Planning and Zoning Board Agenda August 14, 2018

- C. Site Plan - Ellianos Coffee Co.: A request by Christopher Gmuer, P.E., of Gmuer Engineering, Inc., applicant and agent for Circle K Stores, Inc., property owner, for consideration of a Site Plan to construct a ±681 square foot drive through restaurant, with associated paving, grading, drainage, landscaping and infrastructure improvements, on a ±1.03 acre subject property, located at the southeast corner of the intersection of NW US Highway 441 and County Road 235A; Tax Parcel Number 03051-004-000 (Quasi-Judicial Hearing).

- D. Site Plan - Legacy Park Phase 2A: A request by Travis Hastay, P.E., of Causseaux, Hewett, & Walpole, Inc., applicant and agent for the City of Alachua, property owner, for consideration of a Site Plan for the construction of an amphitheater with stage and canopy structure, two (2) multipurpose fields, concessions / restroom building, and associated parking, drainage, paving, grading, and infrastructure improvements on a ±105.68 acre subject property, consisting of a ±17.83 acre project area, located at 15400 Peggy Road; Tax Parcel Number 03870-000-000 (Quasi-Judicial Hearing).

E-1

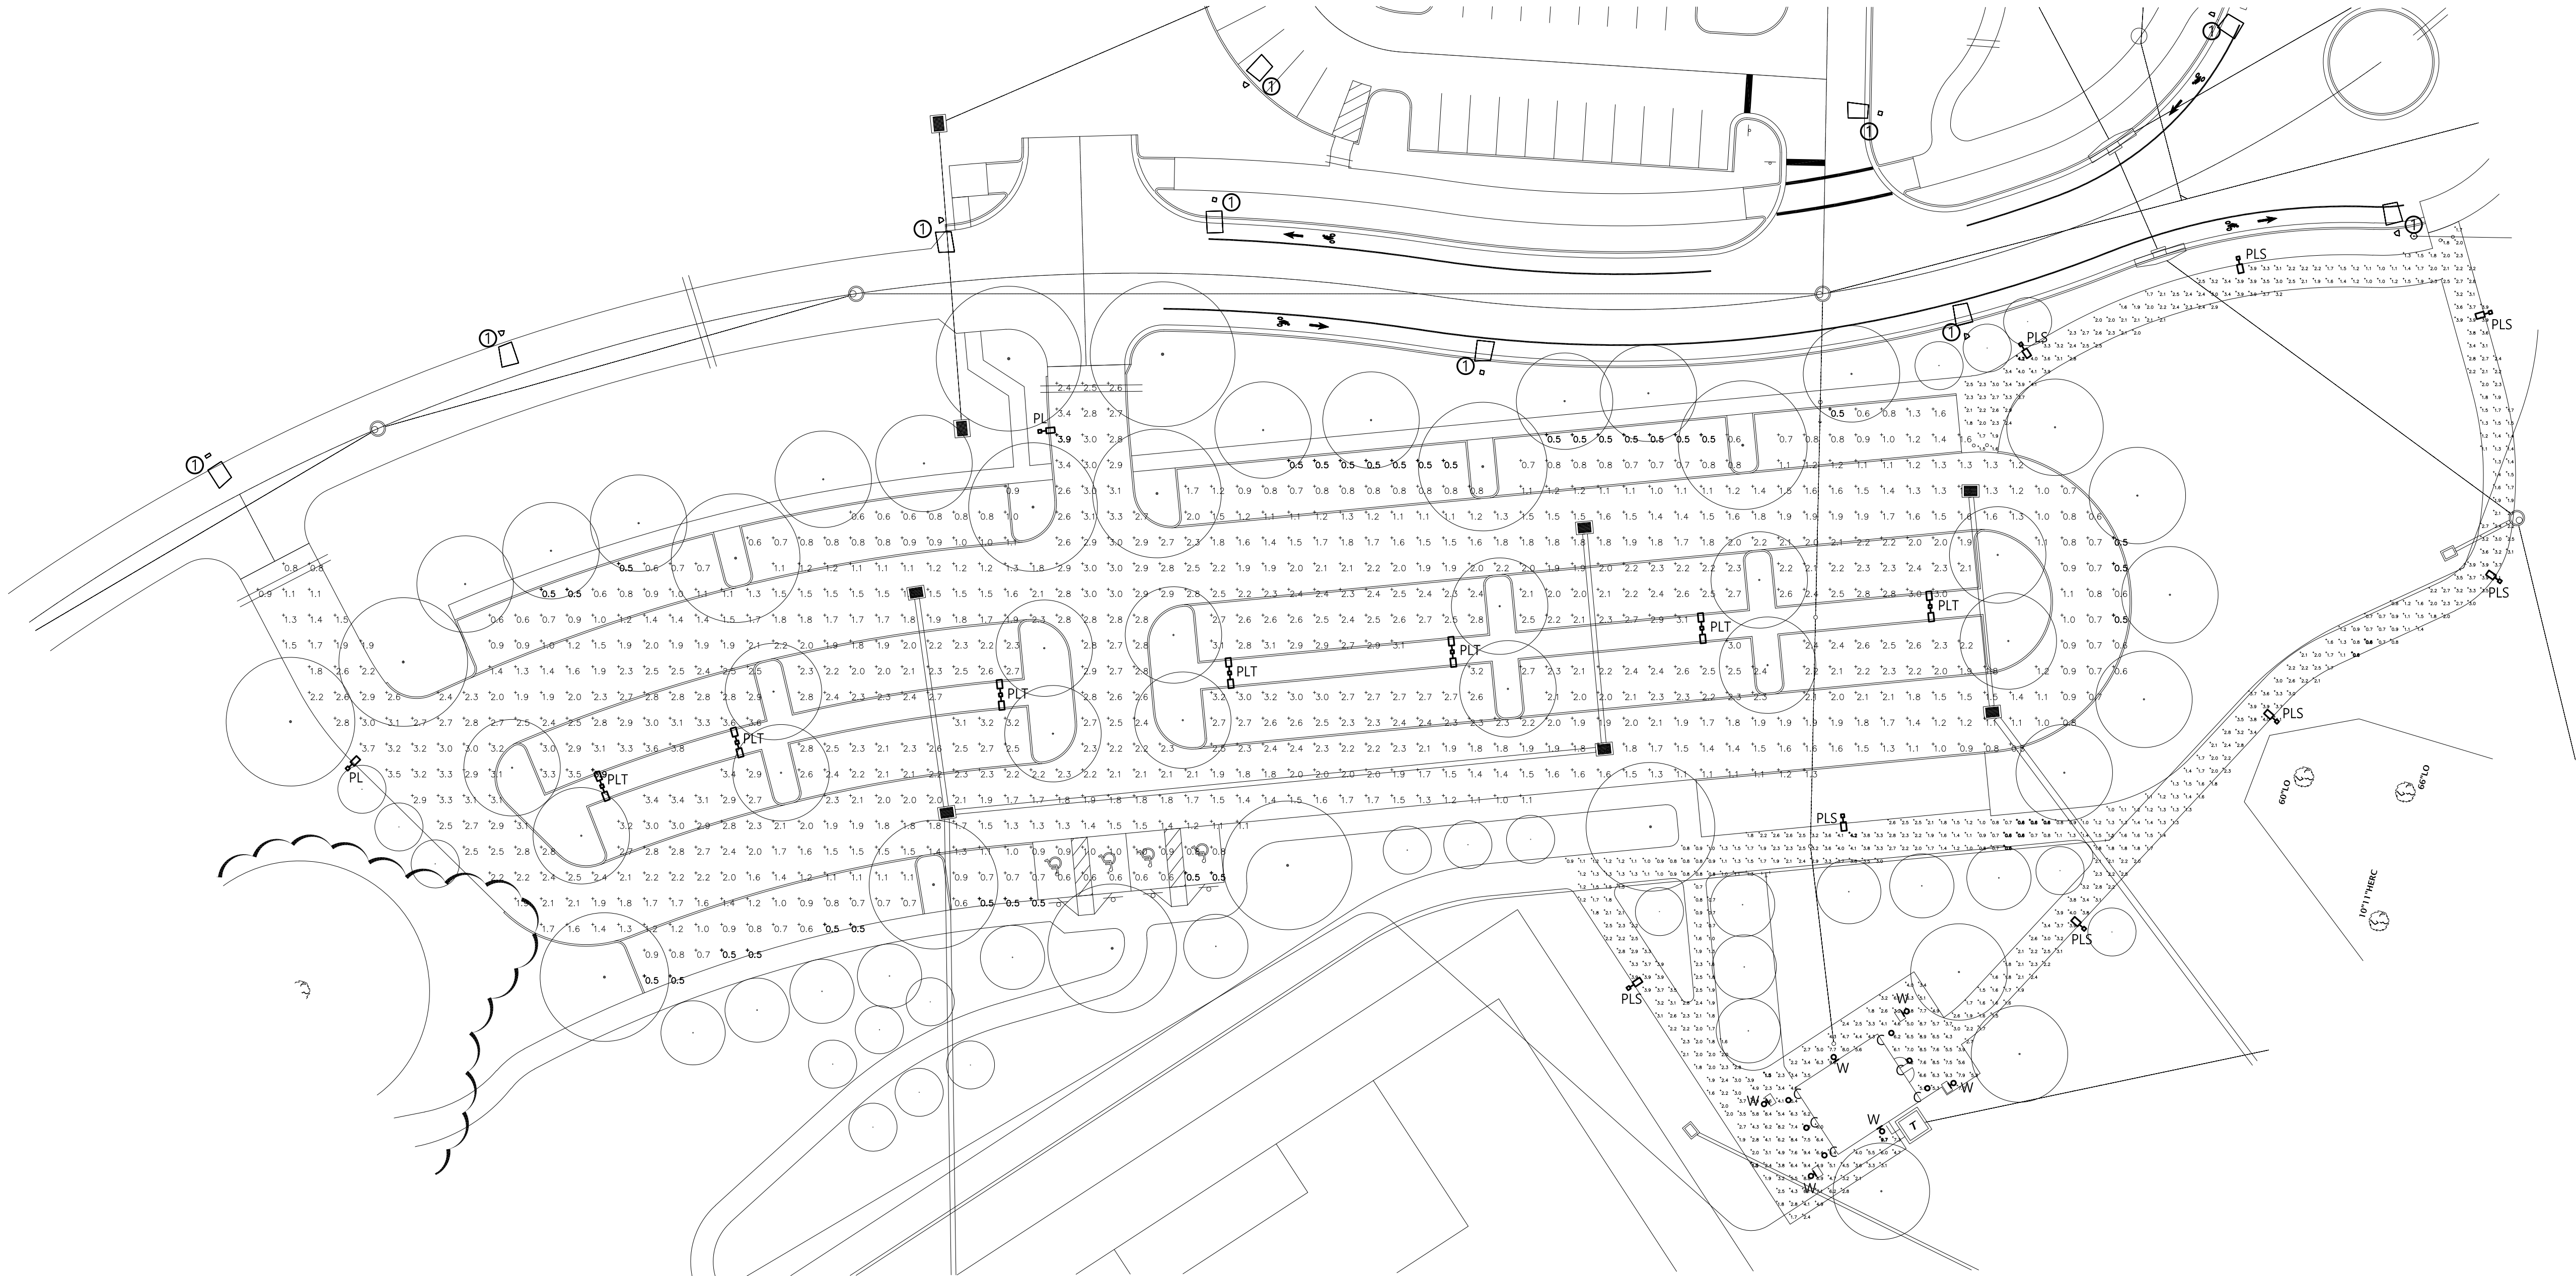
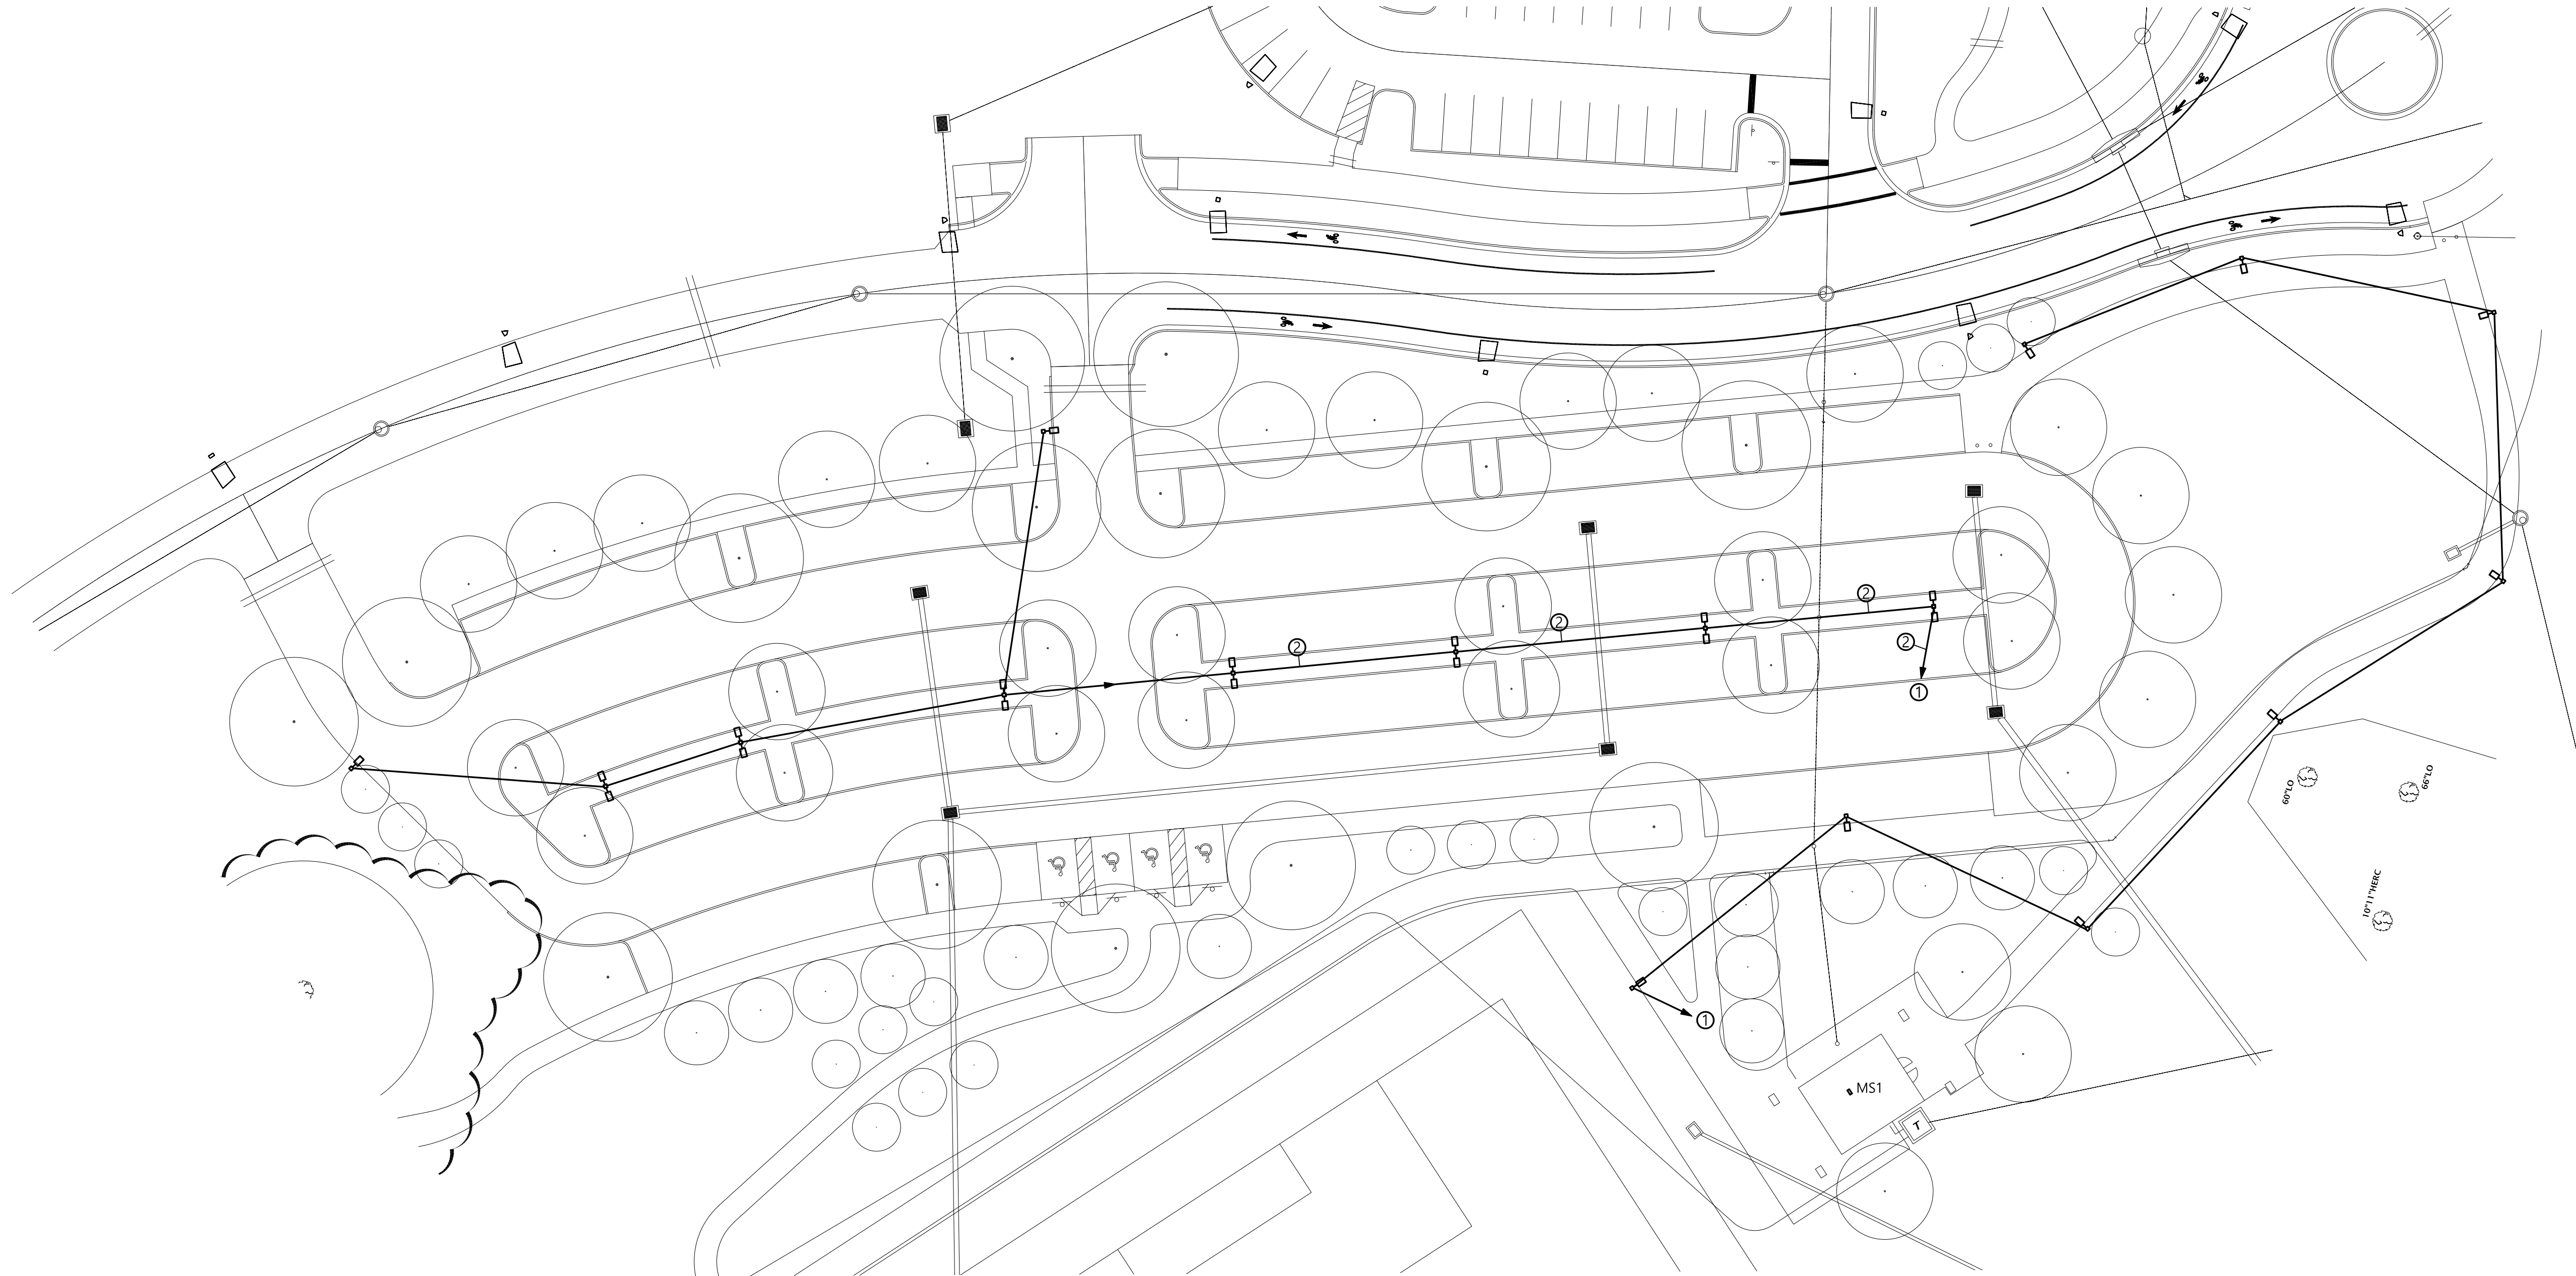
- a. Maximum footcandles within a parking lot (5 footcandles) per Section 6.4.4(C)(2) is exceeded under all PL3T fixtures. Statistics table notes maximum footcandles is 7.2.
- b. Uniformity ratio (maximum to minimum) per Section 6.4.4(E) is 10:1. Statistics table notes max/min ratio of 14.4:1.
- c. Is lighting proposed for the fields? If so, please provide materials to demonstrate compliance with Section 6.4.8.
- d. There are references on Sheet E-1 in the narrative and statistics table to the provisions of 30-6.12. Exterior Lighting Standards are set forth in Section 6.4 of the Land Development Regulations.
- e. If any wall mounted lights are proposed on the concessions building, please identify the lighting and provide detail.
- f. Are any pedestrian level lights proposed along sidewalks? Some lights are provided along sidewalks of the Phase 1 area.
